SUBJECT: Coastside Design Review  
438 Sevilla Avenue, El Granada  
APN 047-055-120; County File No. PLN 2017-00087

At its meeting of November 9, 2017, the San Mateo County Coastside Design Review Committee (CDRC) considered your application for design review to allow construction of a new 2,130 sq. ft., three-story single-family residence, plus a 513 sq. ft. attached two-car garage, on an existing 5,000 sq. ft. legal parcel (COC Type B, PLN 2016-00158). Five (5) Cypress trees are proposed for removal.

Based on the plans, application forms, and accompanying materials submitted, the Coastside Design Review Committee **APPROVED** your project based on and subject to the following findings and recommended conditions:

**PROPOSED SOUTH ELEVATION**

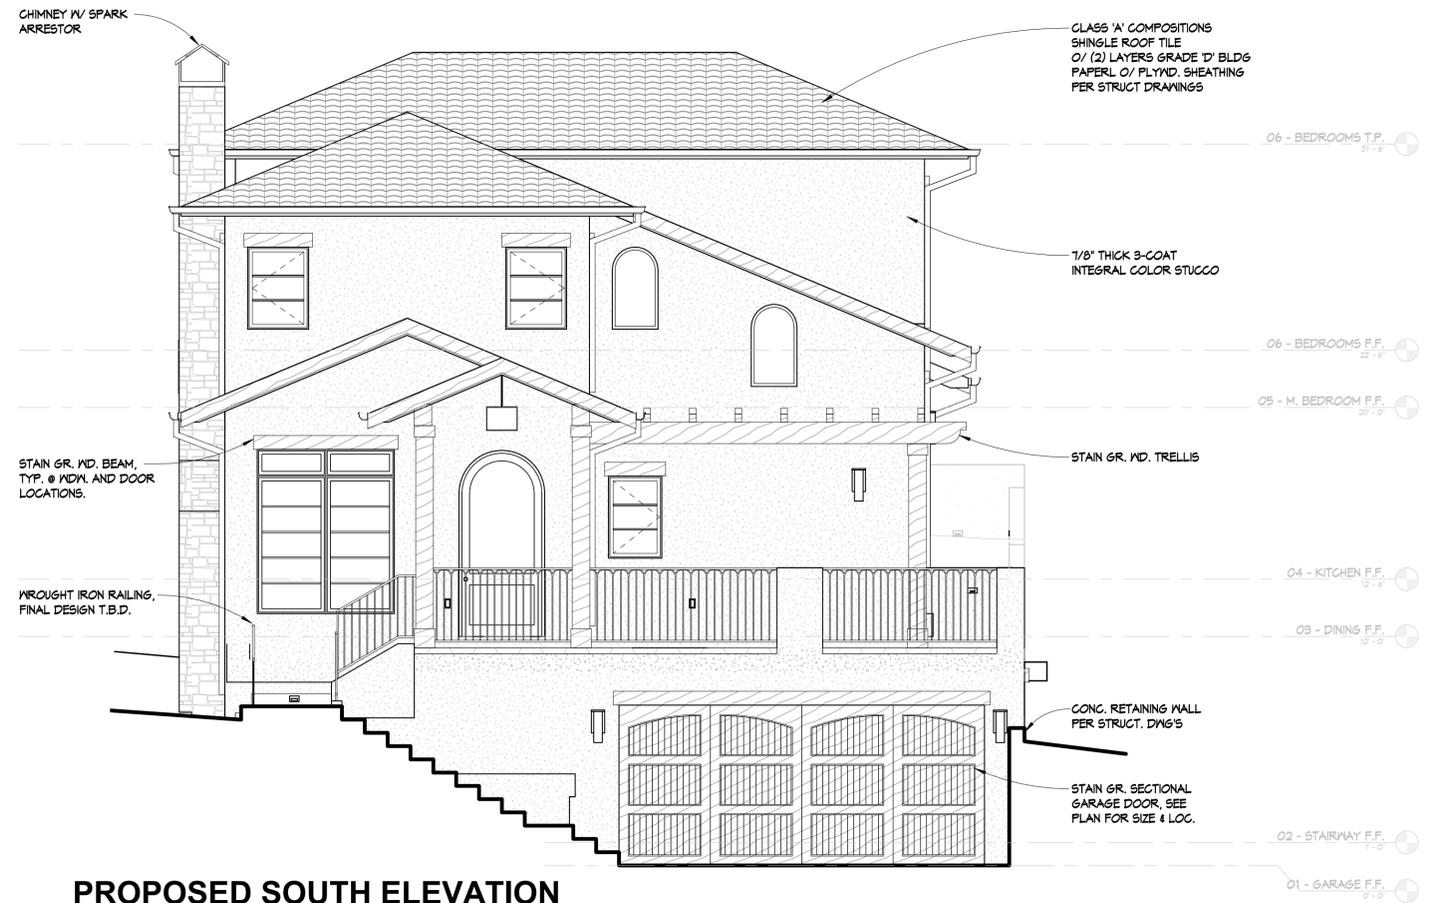
4. The applicant shall indicate the following on the plans submitted for a building permit, as stipulated by the Coastside Design Review Committee:
  - a. Removal of dormers on South Elevation.
  - b. Removal of window above toilet in upper floor hall bath.
  - c. Installation of windows on South Elevation to match scale and size of the windows on the East Elevation. All windows to be casement type except for the window below the stair which can be awning type.
  - d. Reduction of exterior lights to one per exterior door, one on the West Elevation at the stair, and one on each side of the garage door.
  - e. Selection of a more decorative light fixture while still meeting the design requirements for downward-directed exterior lighting.
